Ron & Lynn Duff

August 16, 2019

Re: Preliminary Plat for Lavitt Manor II—Two Lot Subdivision: 7525 N. Ironwood Drive

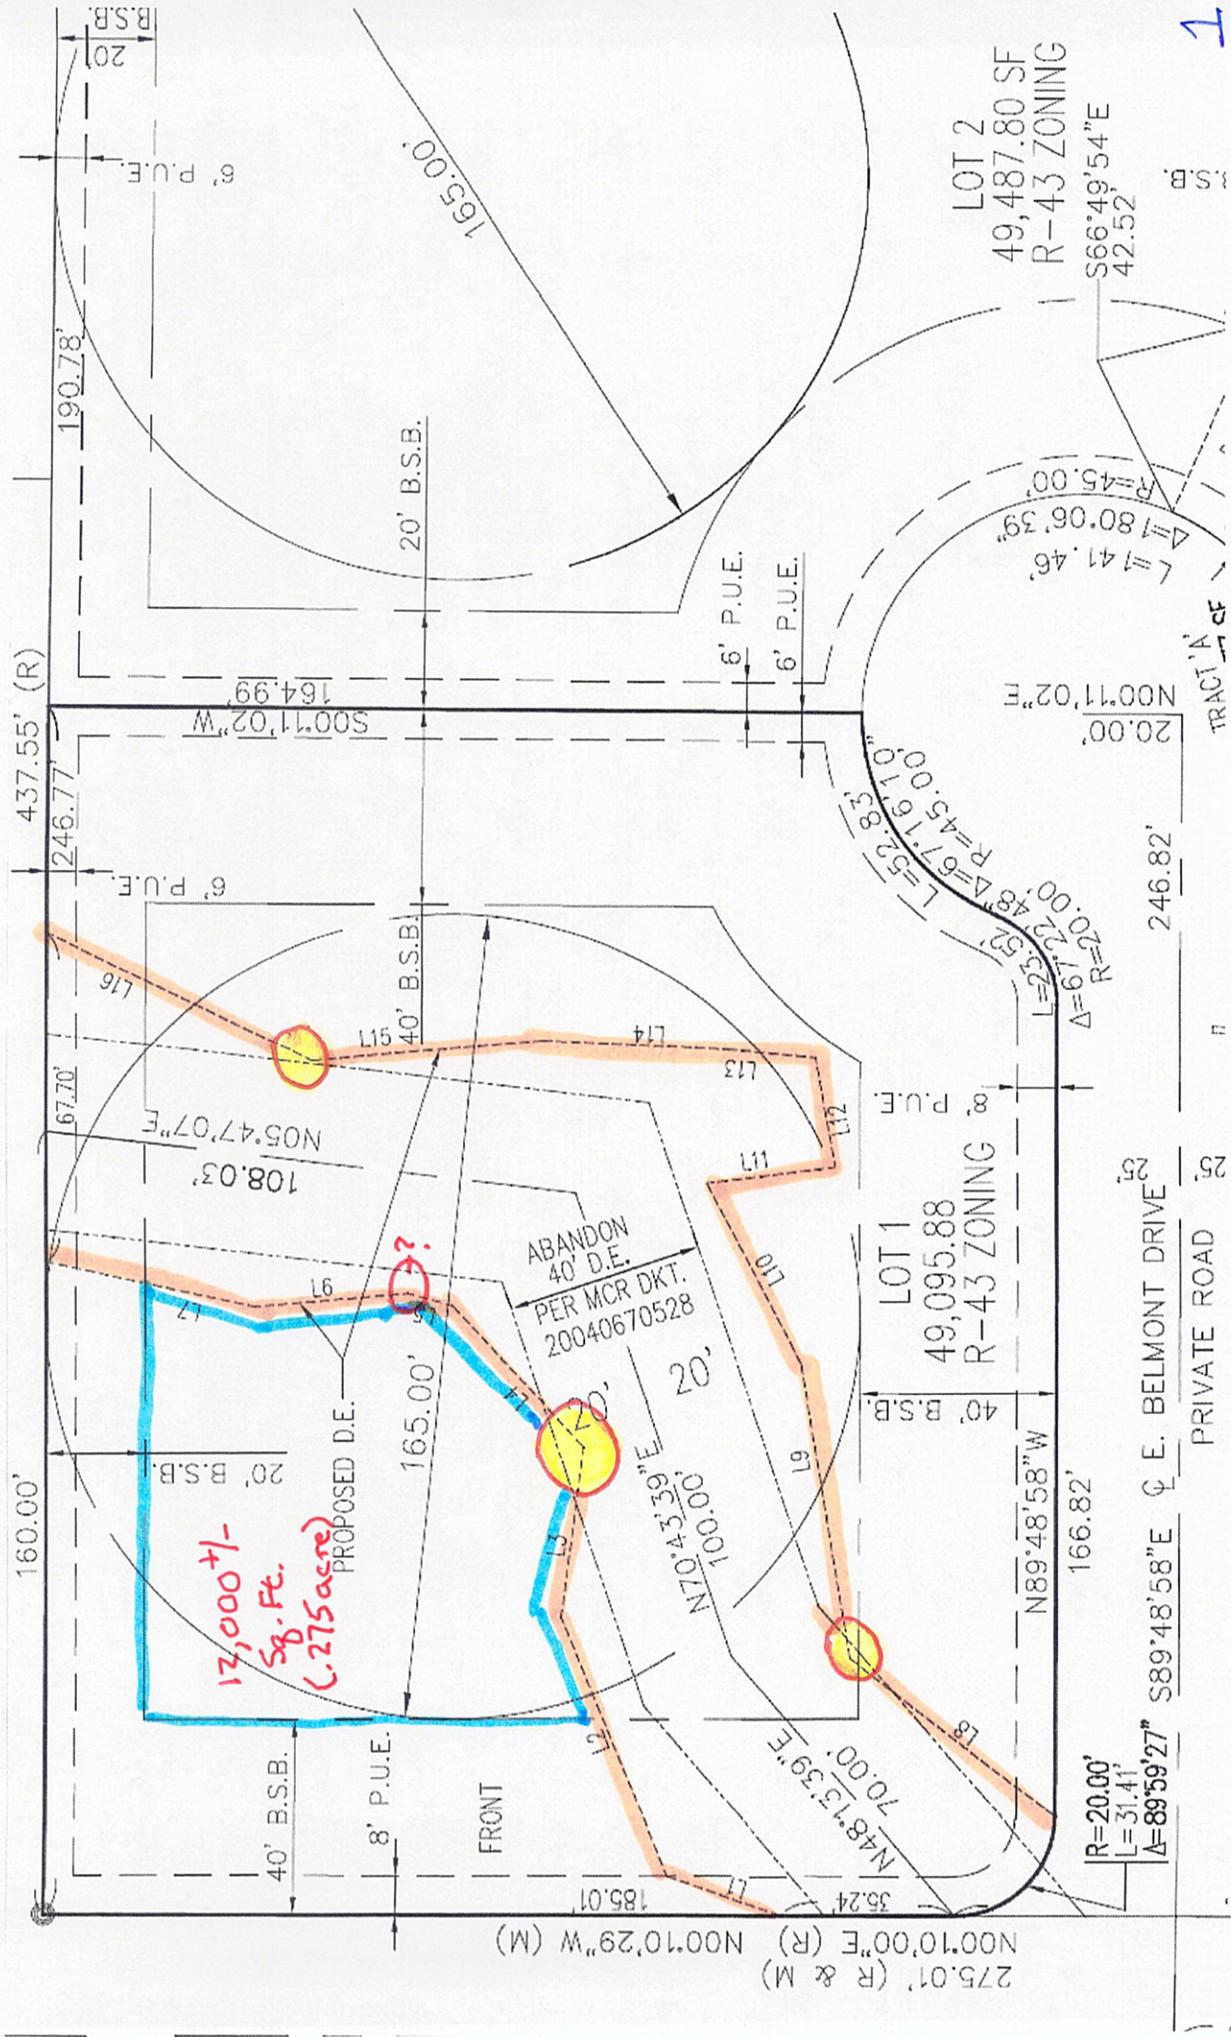
Town Code 3.6(A)(3): Natural Wash Preservation: "Town rights-of-way and easements along Natural Wash corridors **shall be maintained** to preserve the natural environment and landscape features. Natural Wash Corridors **shall include** a landscape buffer of **at least 5 feet on each side**, perpendicular from the **top of the bank** and designed to protect the wash's functional and ecological integrity."

- Town of Paradise Valley is obtaining easement on Lot 1;
- Mandatory language ("shall") to have a 5 foot landscape buffer on each side of wash;
- Current easement points approaches or encroaches Natural Wash at 3 points thus the landscape buffer is not appropriate;
- Plan should not be approved as it violates the Town Code.

PAVING GRADING PLAN LAVITT MANOR II

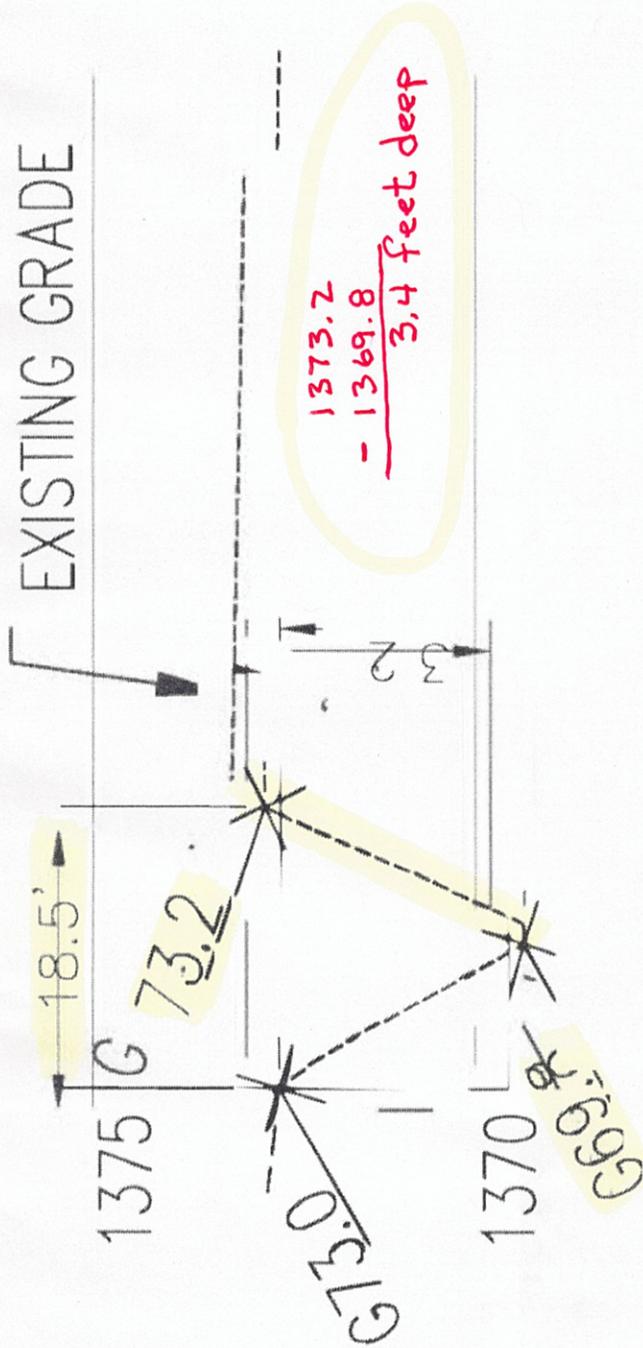
With this understanding, the revised plat points provided by the Applicant on page C3 of 4 of the Preliminary Plat for the Southern Drainage Channel, demonstrate the southern wash meets the definition of a “watercourse” and “Natural Wash” (Exhibits 2-8). The Applicant only took measurements from the shallow side of the wash to reach his conclusion the wash does not require an easement be provided to the Town of Paradise Valley. But as we all know, a wash has two banks—not one. The Code and *Storm Drainage Design Manual* requires measurements from the “top of the bank, which as discussed above, means both banks. When the measurements are reviewed for both sides of the southern wash, it meets the definition of a watercourse and Natural Wash. Applicants must dedicate this wash to the Town.

Plat Points	Elevation Pt. 1	Elevation Pt. 2	Depth of Wash	Width of Wash
C3-7	1373.2	1369.8	3.4 feet	18.5 feet
C3-8	1373.0	1369.7	3.3 feet	8.5 feet
C3-9	1372.0	1369.6	2.4 feet	10.6 feet
C3-10	1371.0	1369.3	1.7 feet	12.0 feet
C3-11	1370.1	1368.2	1.9 feet	14.0 feet

5 OF 5 > 2' VERT HEIGHT
5 OF 5 > 12" LENGTH
D.E. REQUIRED

4 OF 5 < 2' VERT HEIGHT
NO EASEMENT REQUIRED

7
(C.3)

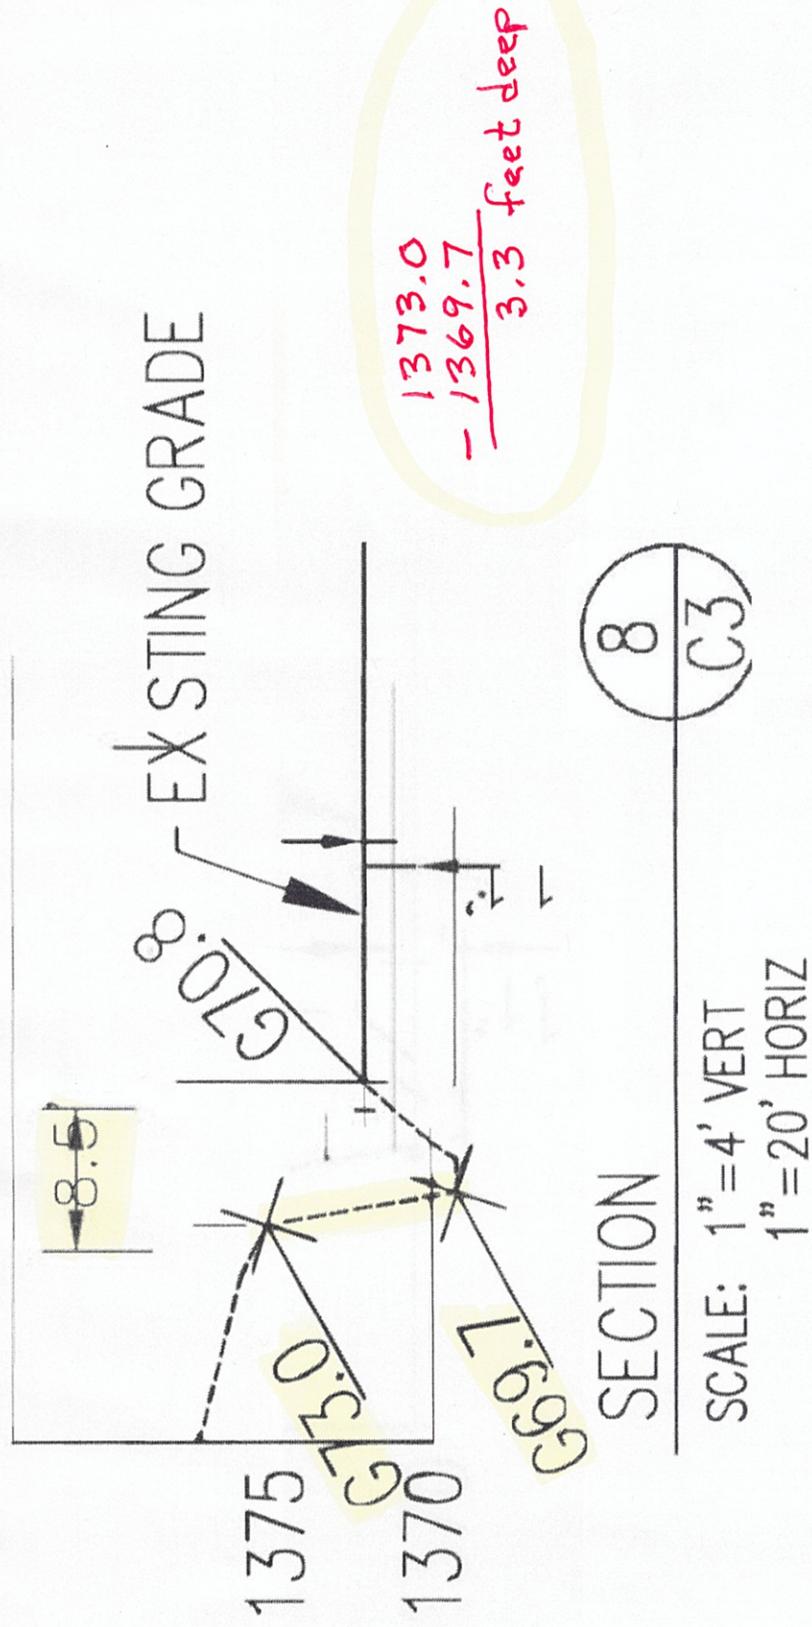
Lowland Paradise Valley Code: §§ 5-10-7(C)(1) and 6-3-8(A): "For the purposes of this section, 'watercourse' means any creek, stream, wash, arroyo, channel or other body of water having historical banks and a bed at least two (2) feet deep and five (5) feet wide through which waters flow on a recurrent basis."

- Must consider both "historical banks" to determine depth;
- Nowhere does it say watercourse depth is taken from one bank, lowest bank, or existing grade of one bank.

Storm Drainage Design Manual: §1.5(A): Natural Wash: "A natural watercourse at least two feet deep from the top of the bank and measuring at least five feet wide at the top of the bank."

- Width must be determined by taking a measurement at the "top of the bank";
 - Can only mean at the top of each bank, or one could not obtain a width measurement from one bank.
- Accordingly, to ensure the same "top of the bank" meaning throughout the provisions, "top of the bank" must mean top of each bank;
 - Depth measurements must be taken from the top of each historical bank of the wash.

3.6(A)(2): Natural Wash Corridors: "To determine if a wash meets the definition of a Natural Wash or Hillside Wash, five cross sections of the wash equally spaced across the property will be provided. If three or more of the cross sections are at least 2 feet deep from the top of the bank and 5 feet wide to the top of the bank, the wash is considered a Natural Wash or Hillside Wash.

- Width must be determined by taking a measurement "to the top of the bank";
 - Can only mean to the top of each bank, or one could not obtain a width measurement from one bank.
- Accordingly, to ensure the same "top of the bank" meaning throughout the provisions, "top of the bank" must mean top of each bank;
 - Depth measurements must be taken from the top of each historical bank of the wash to determine if it is a Natural Wash.
